Section 75W Modifications Report

Project Application No. 06_0199
Freeway North Business Park

Report No: 21717

Version/Date: Version 2, 23rd June 2010

Proposed Subdivision & Staging Plan

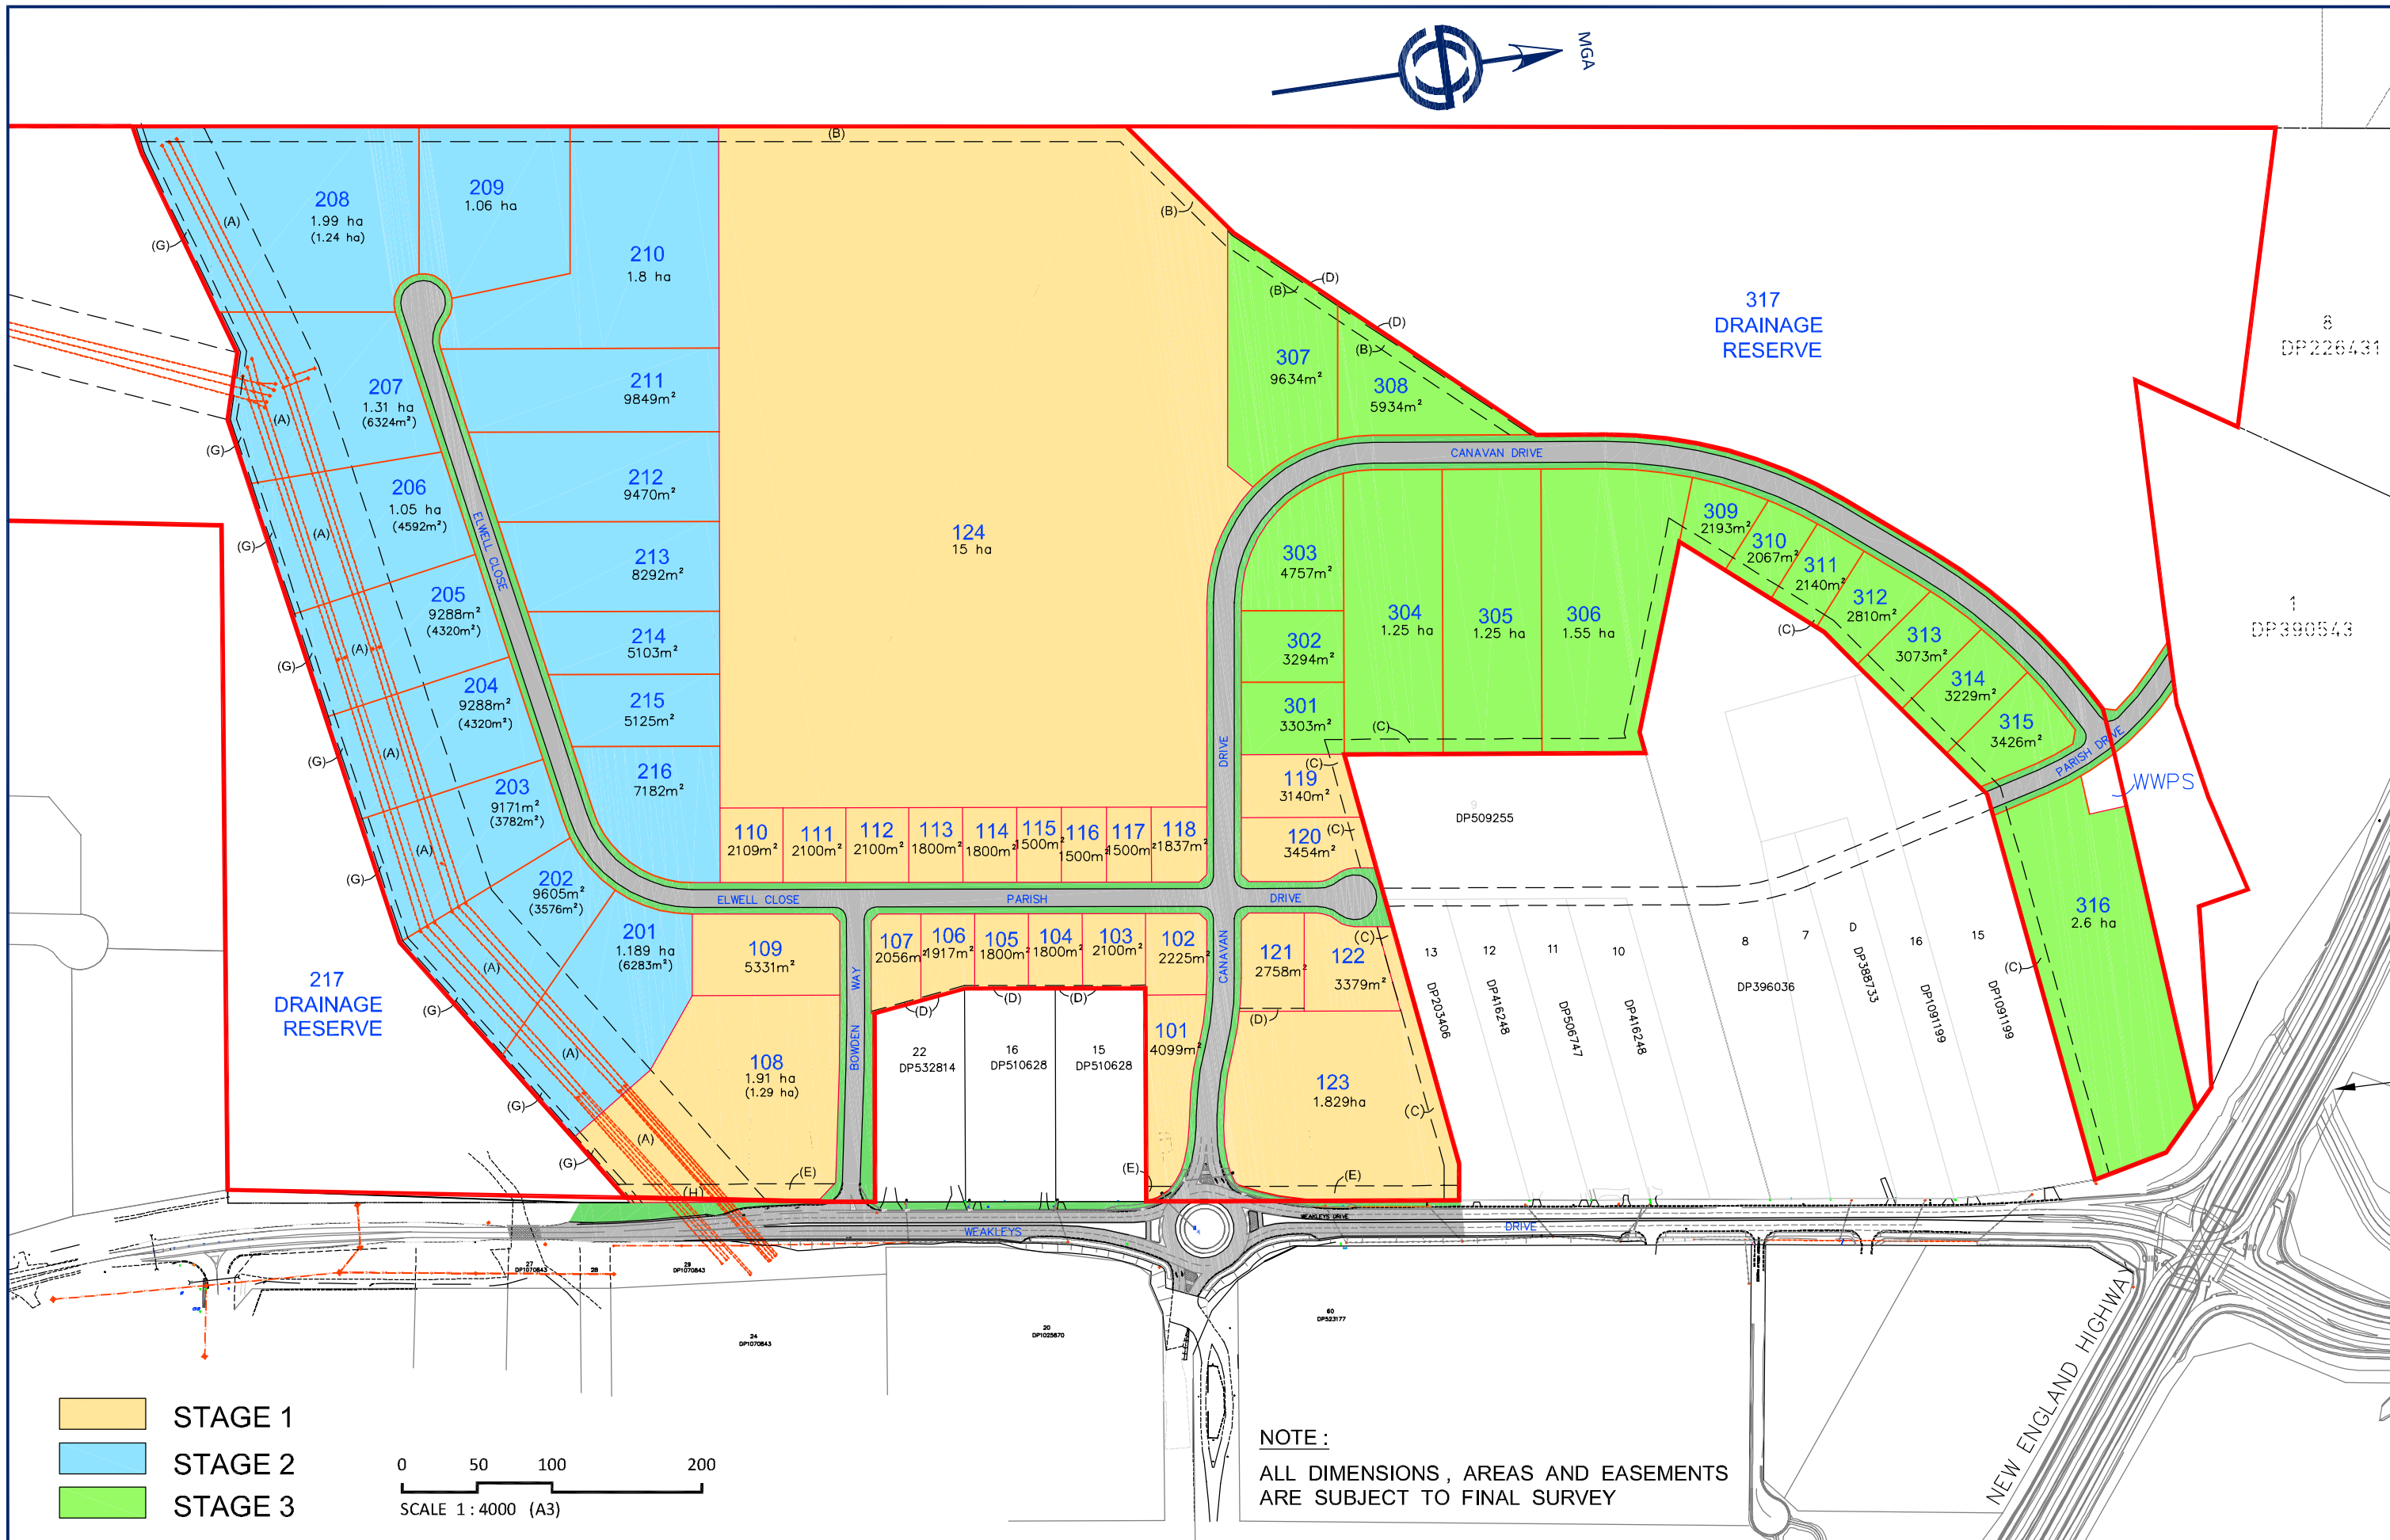
In order to accommodate the Aldi Regional Distribution Warehouse on the land, amendments to both the road and lot layout will be required. These are illustrated in the proposed subdivision & staging plan contained in Appendix 2.

The proposed site for the Aldi Regional Distribution Warehouse (proposed Lot 124) is approximately 15ha and incorporates the following lots, as per the approved subdivision plan:

- Part 18-26, Part 49, 50-58, Part 59, Part 60, 61-62, Part 63, 66-67, Part 68 and Part 69, 71, 86-88 and part of the road reserve of Road 4 and Road 6.

In addition, the following amendments to the road layout of the approved subdivision plan are proposed:

- Road 3 is relocated such that it aligns with Road 2 and continues along the alignment of the approved Road 2 (now referred to on the modified subdivision plan as Parish Drive).
- Road 4, to the west of approved Road 3, is incorporated into proposed Lot 124 (i.e. the Aldi Regional Distribution Warehouse site). Part of Road 6 is incorporated into proposed Lot 124 and the western extremity deleted.
- Road 1 (now referred to on the modified subdivision plan as Canavan Drive) and Road 5 (Elwell Close) remain in their original positions.

As a result of the revised road layout and amalgamation of lots, some minor reconfiguration of the surrounding allotments will also be required. This includes the removal of the detention basin (shown as drainage reserve on the approved layout in Appendix 1) as it is no longer required as detailed in section 2.4 of this report and within the Stormwater Drainage Report in Appendix 4). Such reconfiguration will have no additional environmental impact to the already approved industrial subdivision.

Staging of Freeway North Business Park was approved over four stages to ensure that a logical development of the site is achieved with the appropriate release of land as required. As a result of the proposed modification to the approved industrial subdivision, it is now intended to develop the site over 3 stages. A modified Staging Plan has been prepared and is contained in Appendix 2. The modified Staging Plan includes:

Stage 1 – Lots 101 – 124 (Lot 124 being the 15ha allotment for the proposed Aldi Distribution Warehouse)

Stage 2 – Lots 201 – 217, with Lot 217 being a drainage reserve and dedicated to Council.

Stage 3 – Lots 301 – 317, with Lot 317 being a drainage reserve and dedicated to Council.

**DETAILED CATCHMENT PLAN
FIGURE 3**

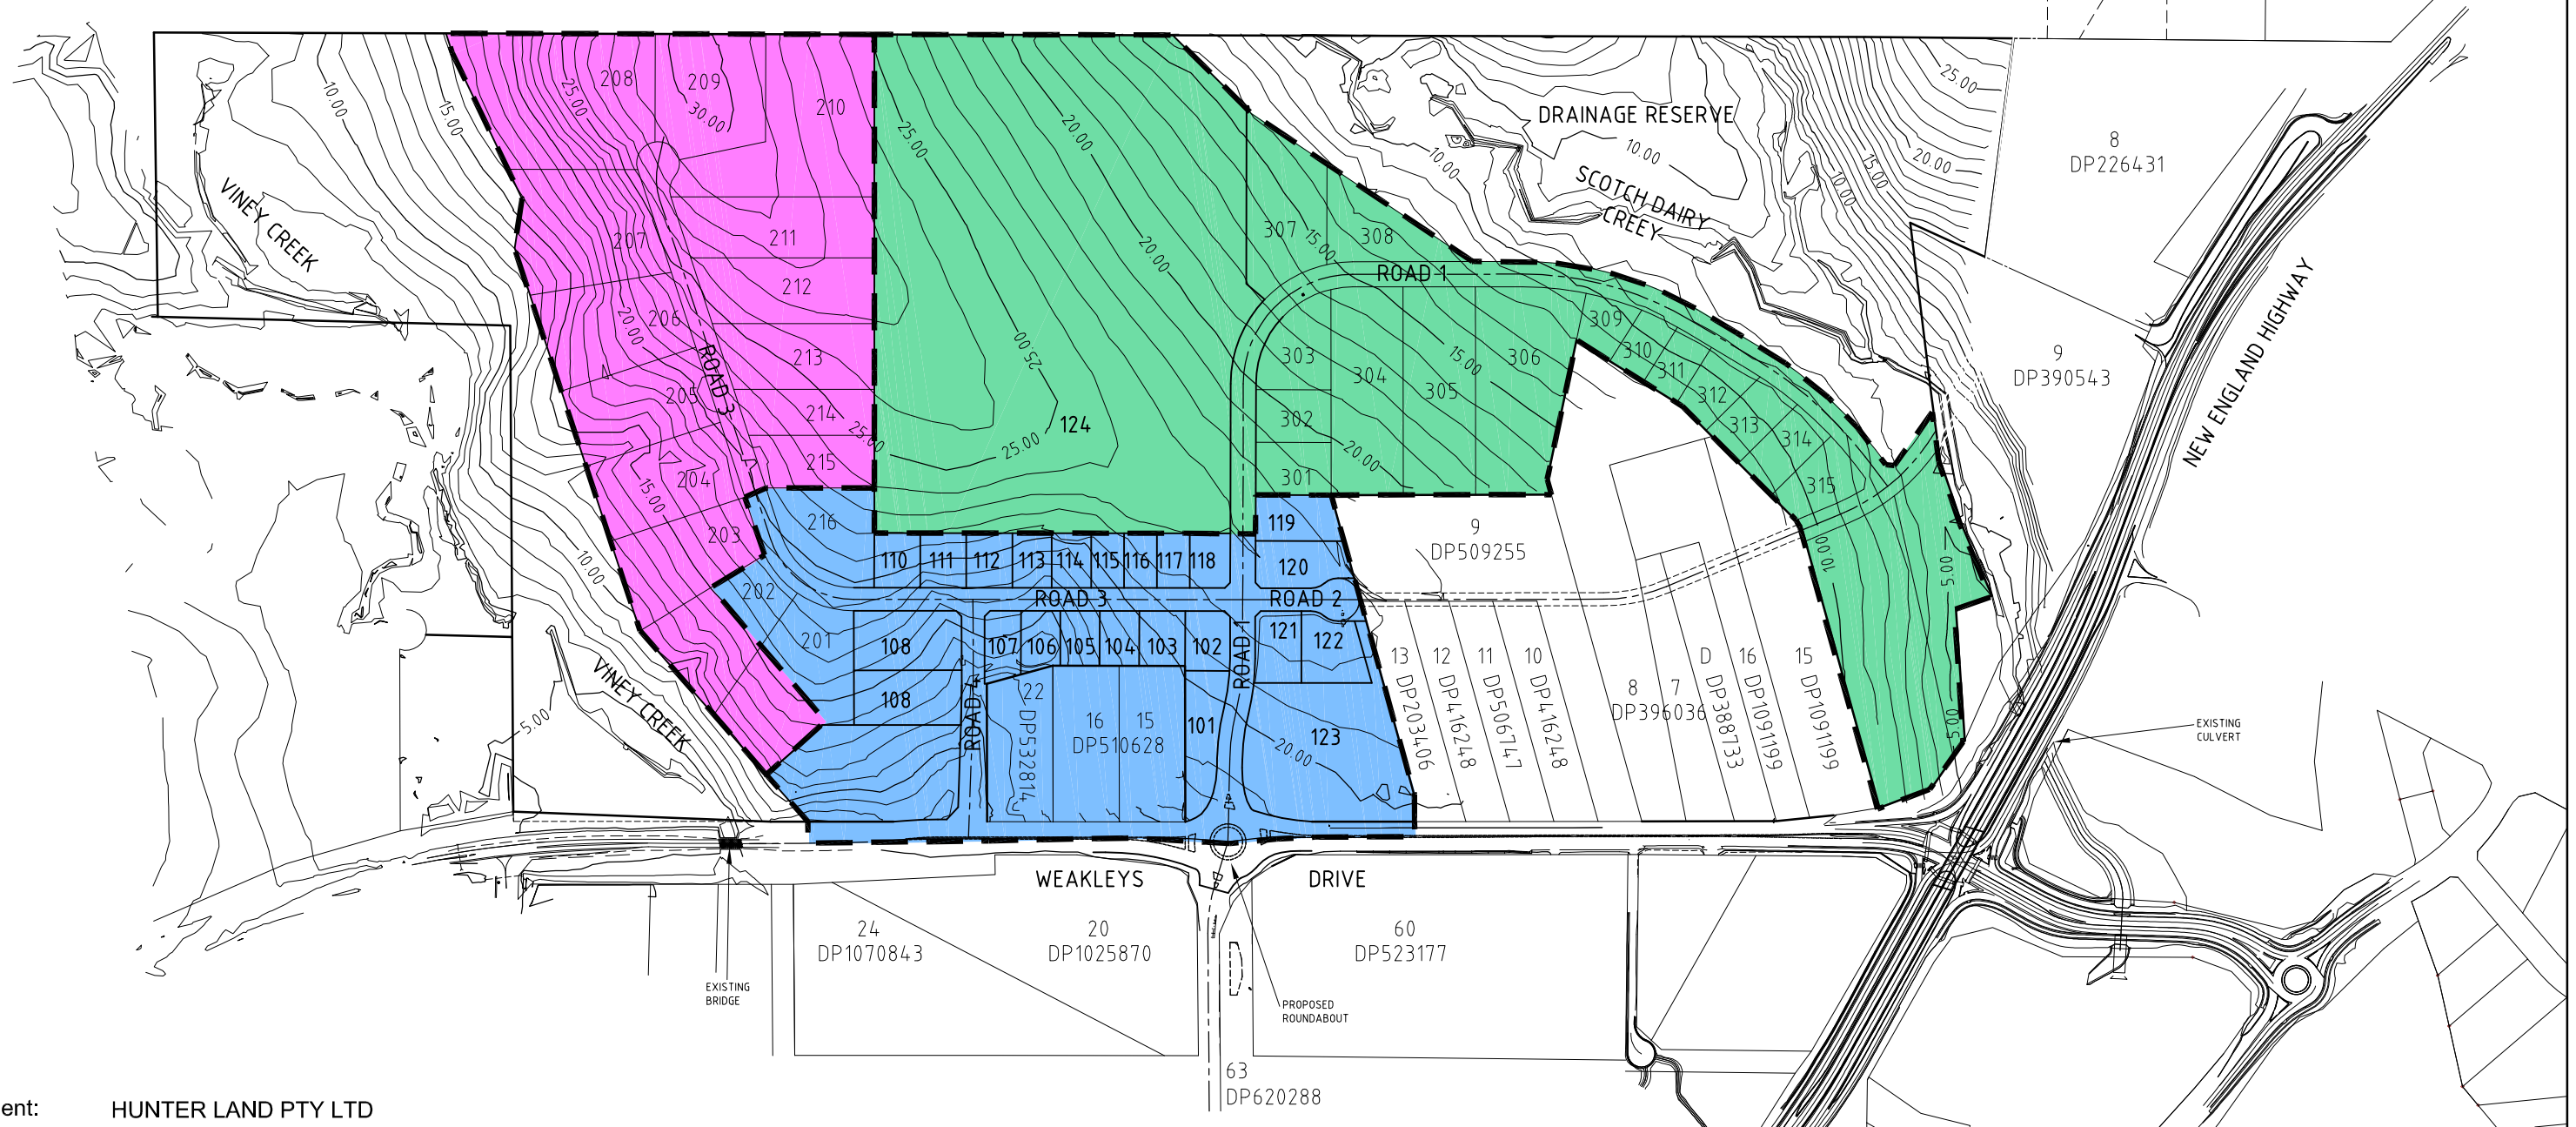
The report proposes to divert the developed Catchment 2 towards Viney Creek (a detailed catchment plan is included in Figure 3 of the Stormwater Drainage Report in Appendix 4). The change in flow regime proves that the addition of flow from Catchment 2 does not increase the existing peak flow in the 100 year ARI event because Catchment 2 is located immediately upstream of the existing bridge in Weakleys Drive. For this reason, the provision of a detention basin in Stage 1 of the subdivision to cater for flows from Catchment 3 is no longer required.
